Technical Note

Project:	Hilfield Solar farm Glare and Glint Study		
Subject:	Review of applicants Glare and Glint Study		
Author:	David Mooney		
Date:	28/05/2021	Project No.:	5193383
Distribution:	Max Saunders	Representing:	Hertsmere Council

Atkins have been commissioned to provide a 3rd party review of the Glare and Glint Study (G&G) produced for Enso Energy by Pager Power covering the proposed Solar Farm Development adjacent to Elstree Aerodrome. The documents under review are: -

Road receptor mitigation requirement flow chart

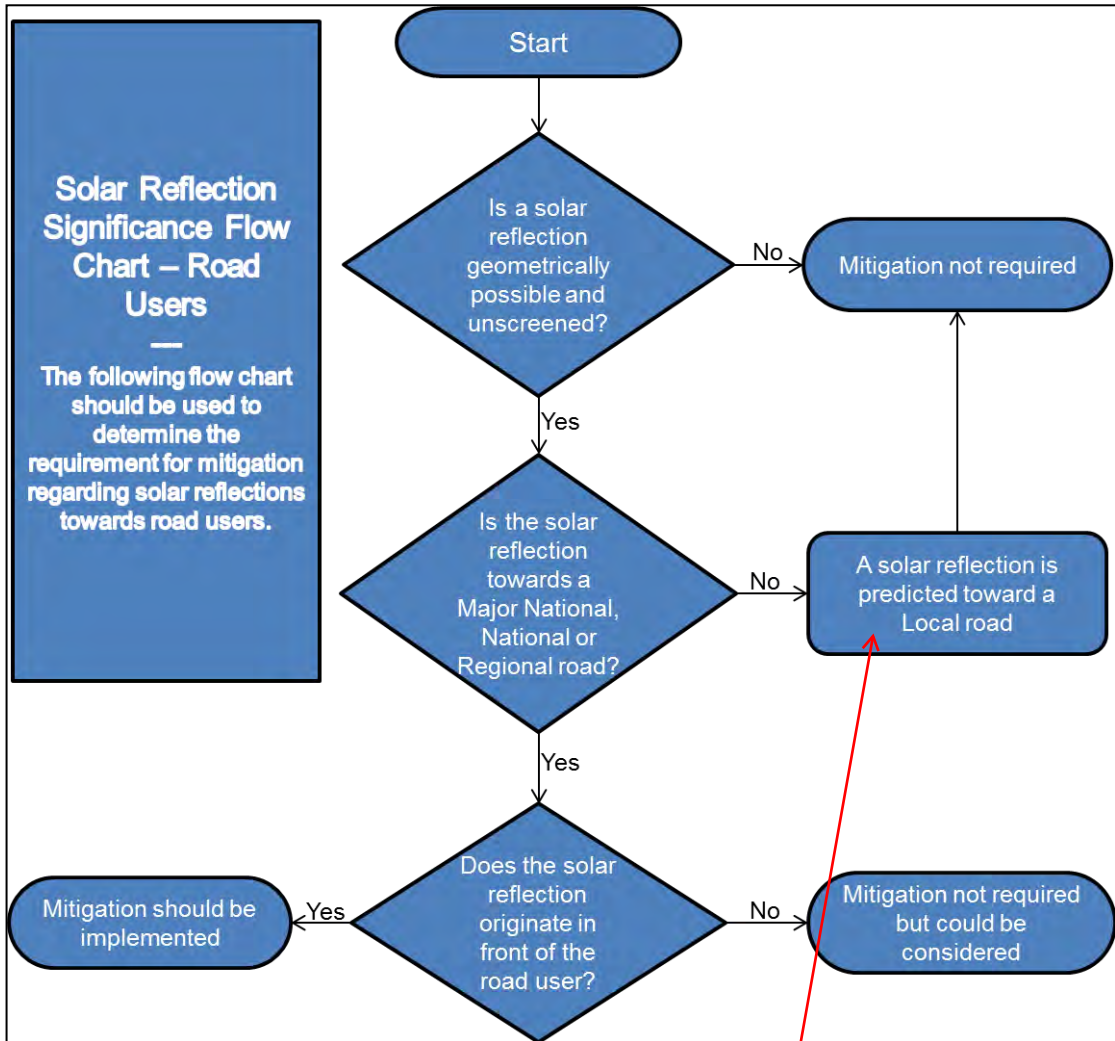
- a. Aviation process no comment.
- b. Assessment process road users this flow chart does not take into account the fact that Highways England consider local roads to be the most dangerous.

Dwelling receptor mitigation requirement flow chart

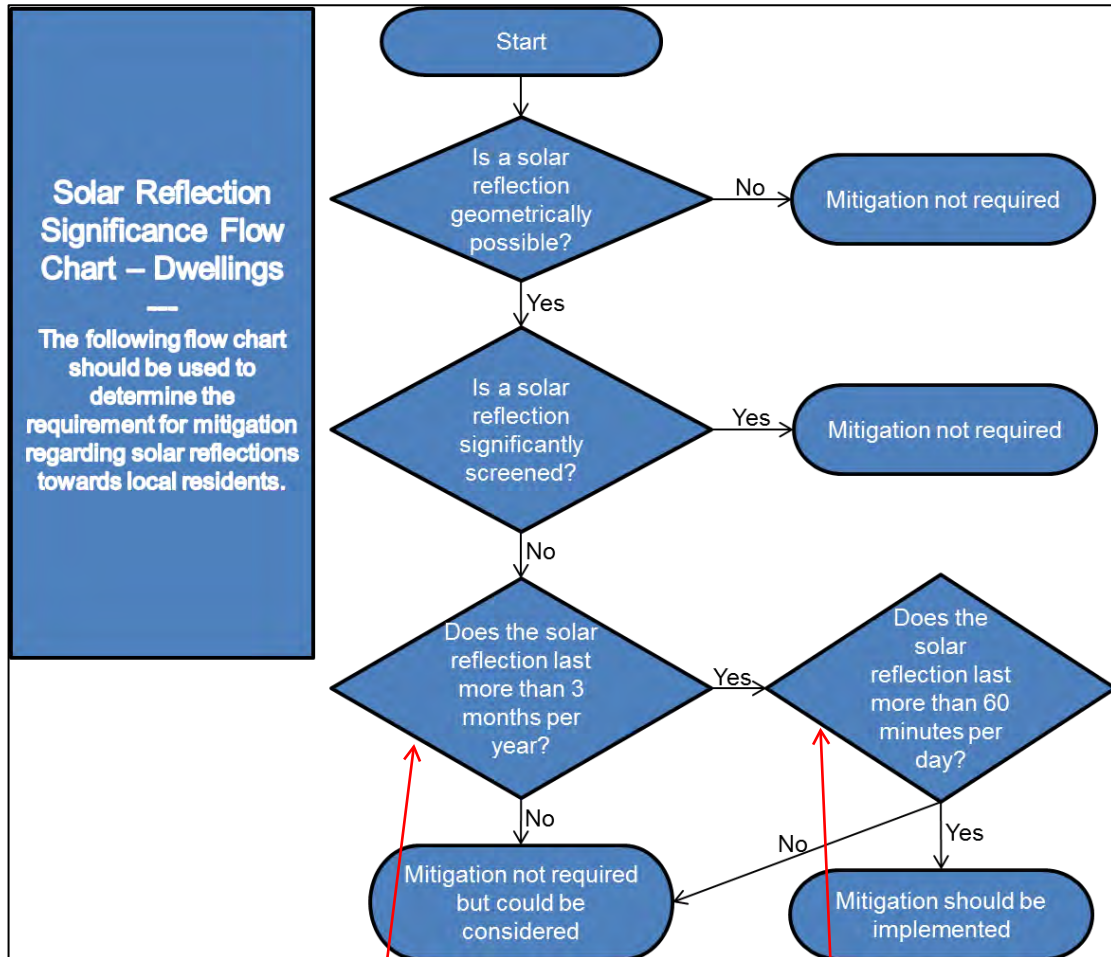
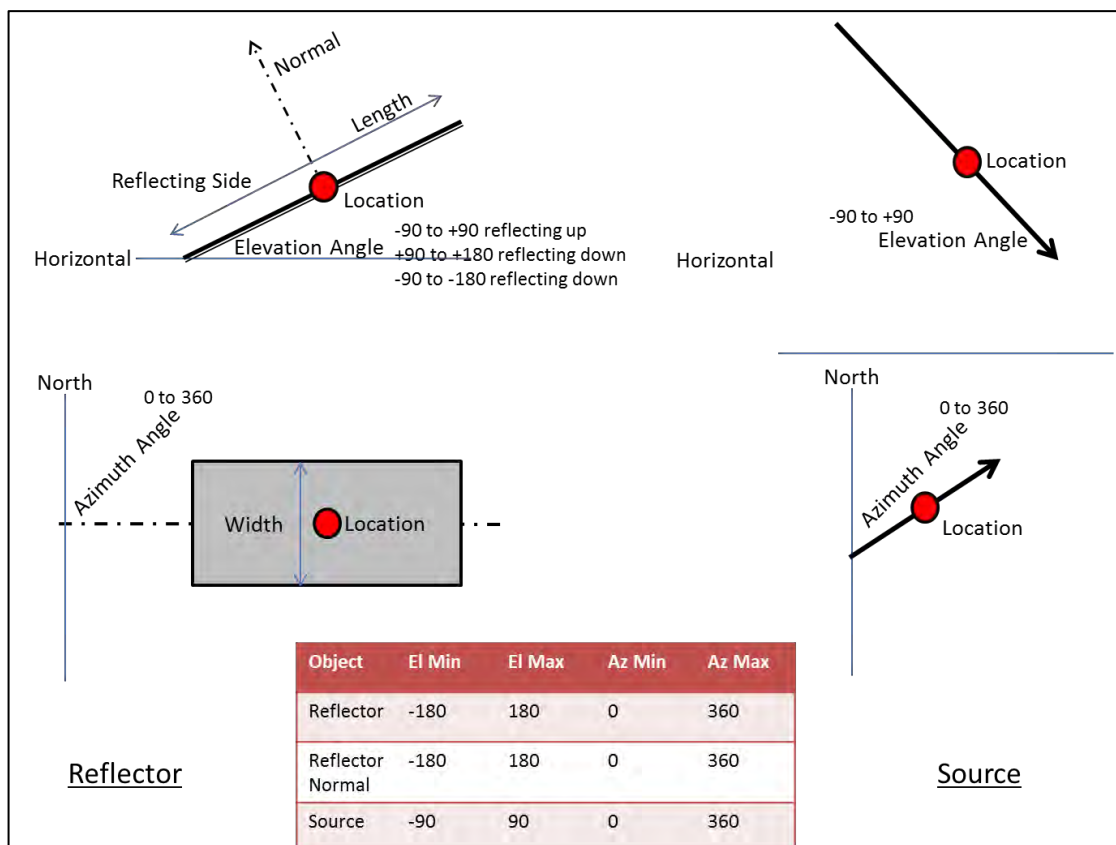
Why 3 months, a week could be significant ?

Why 60 mins, it only takes 10 minutes to wake someone with sunlight ?

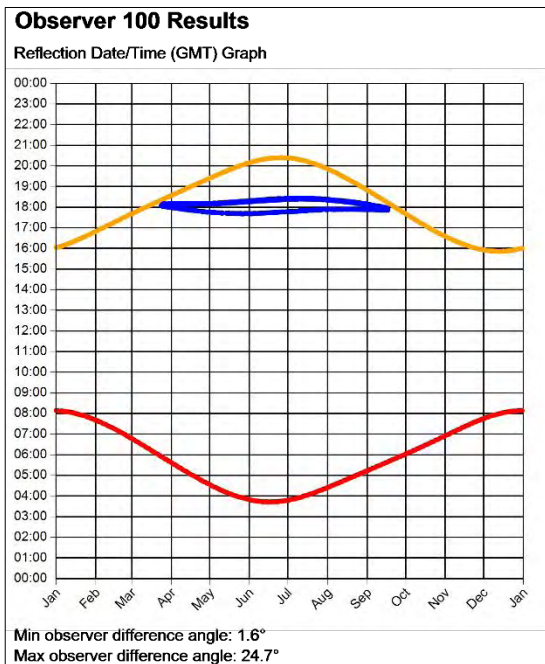
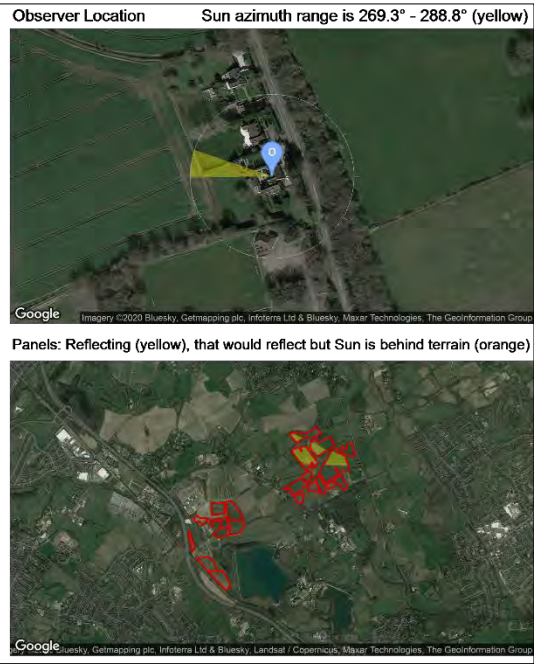
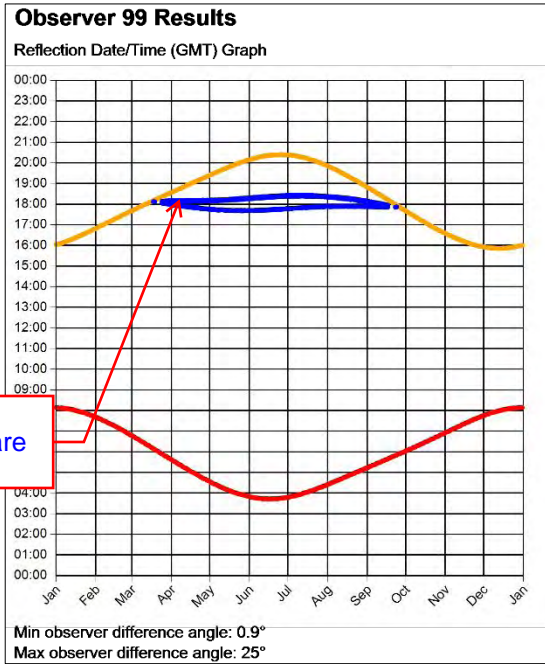
what is the time duration of the glare each day.

APPENDIX I - LEEP PLAN

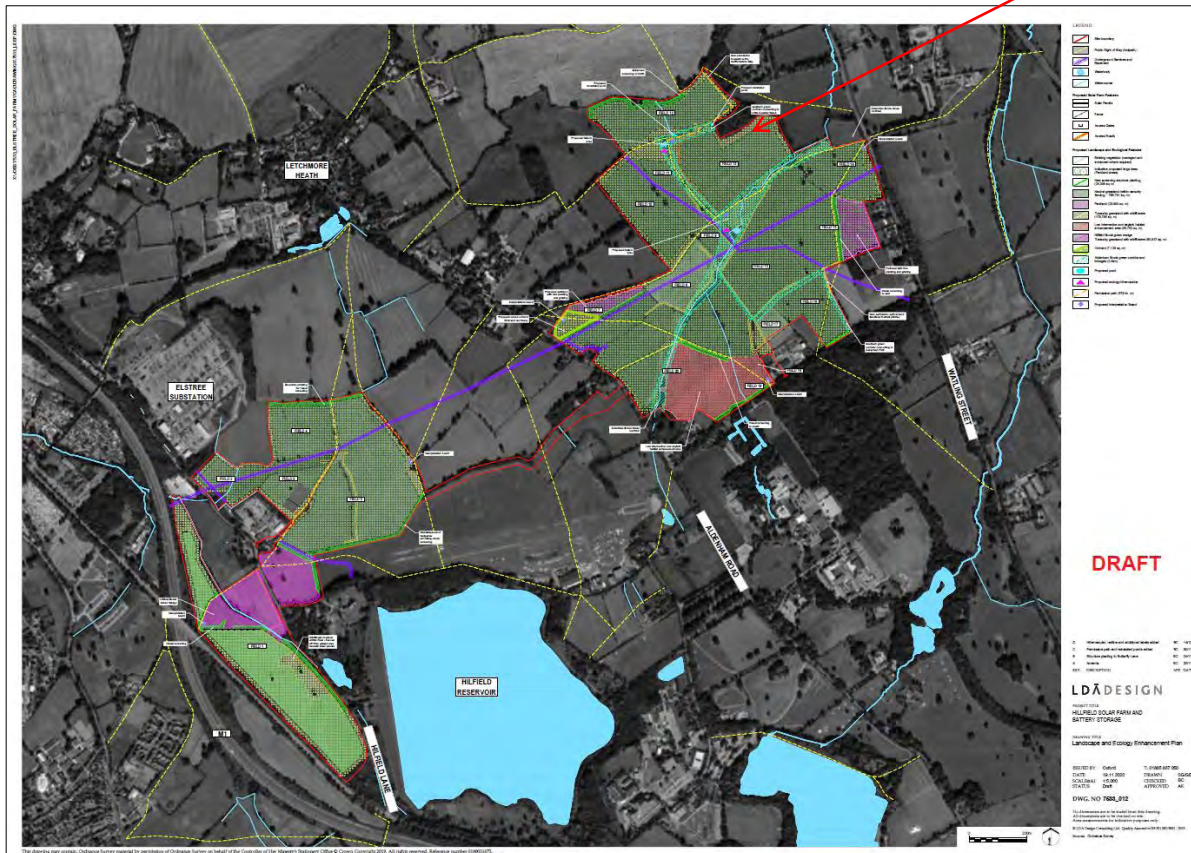
This is unreadable.
